MILITARY SPECIFICATION

SEMICONDUCTOR DEVICE, TRANSISTOR, PNP, GERMANIUM, LOW-POWER
TYPE 2N393

This amendment forms a part of Military Specification MIL-S-19500/77C, dated 6 March 1968, and is approved for use by all Departments and Agencies of the Department of Defense.

FIGURE 1. Physical dimensions of transistor type 2N393.

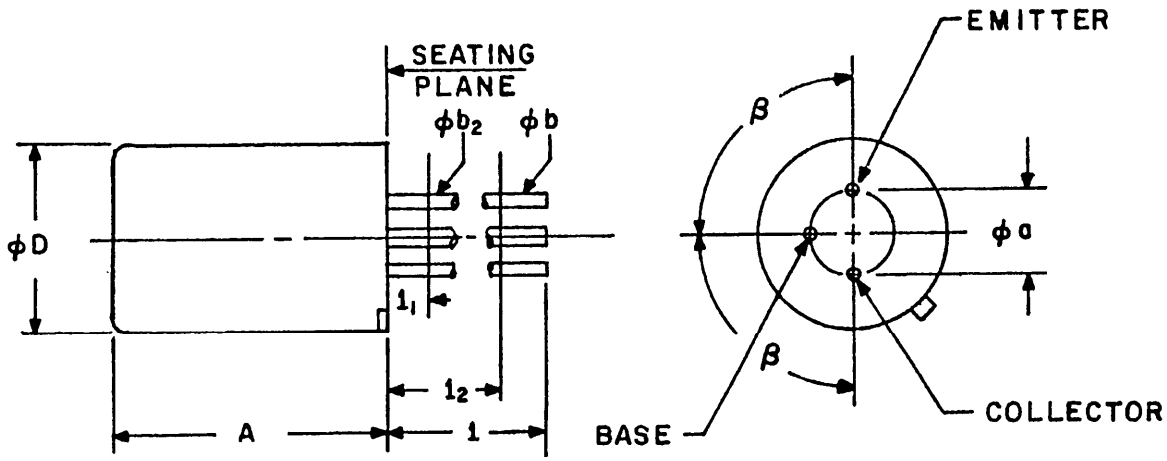
* FIGURE 1: Delete and substitute new figure 1 as printed on page 3 of this amendment.
